## DEVELOPMENT ASSESSMENT REPORT Shire of Augusta Margaret River 5 September to 11 September 2024

Date Rec'd	Reference No.	Address	Proposal	Recommendation
PLANNING				
21/03//2024	P224213	4 (Lot 179) Bayview Drive, Gracetown	Amendment to P222244	Conditional Approval

Application Botalio				
Address	4 (Lot 179) Bayview Drive, Gracetown			
Proposed Development	Amendment to P222244 – Proposed Mixed Use Development. A development application for a proposed mixed use development consisting of Offices x 6 and upper floor apartment was originaly approved on 19/08/2022.			
Zoning	Village Centre			
Lot Area	1315m <sup>2</sup>			
Use Class and Permissibility	Multiple Dwellings – 'D' Office – 'P'			
Heritage/Aboriginal Sites				
Other Considerations	Visual Management Area		Sewerage Sensitive Area	
	Special Control Area			
	Bushfire Prone Area			
Structure Plans/LDP's	Nil			
Easements/Encumbrances	Easement - The easement is in relation to a previous agreement

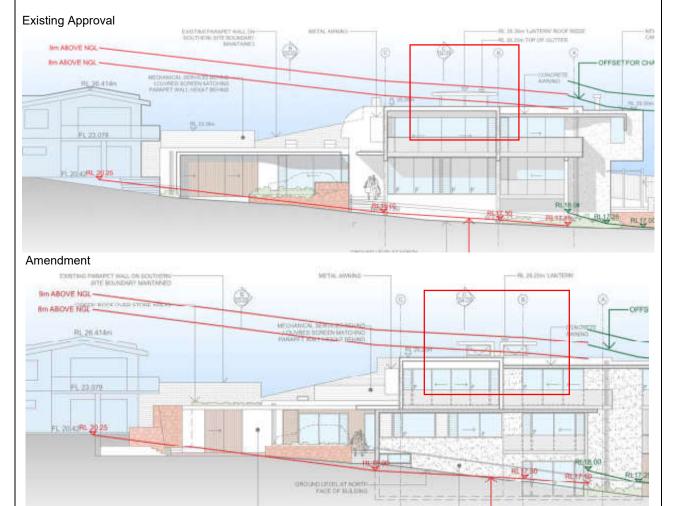
The proposed development, as was the case with the previously approved application is generally utilising the existing building envelope with a proposed roof lantern above the kitchen.

The site slopes from the southern boundary to the northern boundary resulting in a sloping natural ground level. The existing parapet wall on the southern boundary is compliant with the 7m wall and 8m roof height.

The variation is associated with the roof lantern projecting from the roof of the building proposes a variation to the prescribed maximum wall height in LPS1 of 7m, the roof height is compliant with the maximum 8m. The roof lantern has been conservatively calculated as an extension of the internal wall and therefore required to meet the 7m maximum wall height limit. This is consistent in its location and scale with the previous approval as depicted below.

Clause 5.13.1.12 of the Shire's LPS1 allow the height limits specified to be varied by not more than 20%, where certain criteria are met. Clause 5.13.2 allows for height variations to be considered where the local government is satisfied that the proposed building will be in harmony with the general character of buildings in the locality and will not adversely affect the beauty, character, quality of environment or the area generally. The proposed development is maintaining the existing roof height, with the addition of a roof lantern over the top of the kitchen. The proposed height variation is not considered to have a major visual amenity impact and has been designed sensitively to reduce impacts where possible. The proposed height variation is supported and is capable of approval.
